## FCC Class II Permissive Change Request Letter

RE: FCC Permissive II Change Request for Company: DewertOkin Technology Group Co., Ltd.  
FCC ID: 2AVJ8-CB4620

New	Original
Product Name: CONTROL BOX	
Model: CB4620 (add 2 resistor )	Model: CB4620

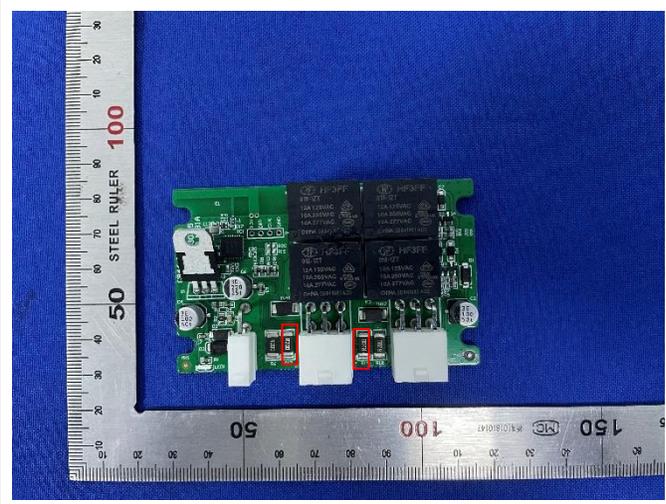
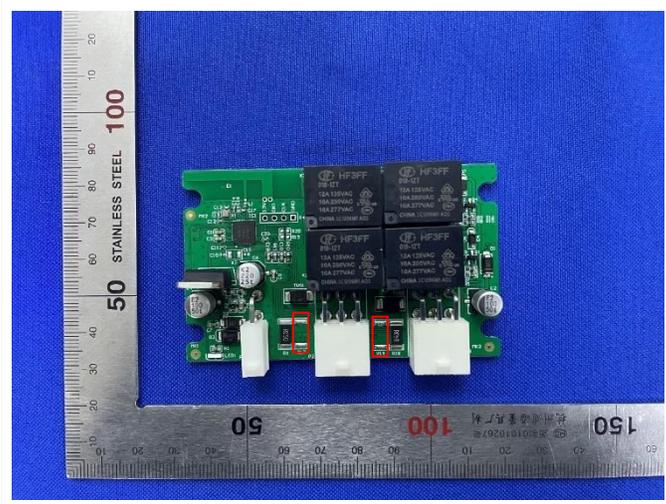
1. Only added 2 resistors, Due to the change of load, the previous resistance is changed to two welding, so that the load resistance of the whole machine is stronger. This change only affects the motor control part, which is separate from the RF part, so it does not affect the RF circuit.
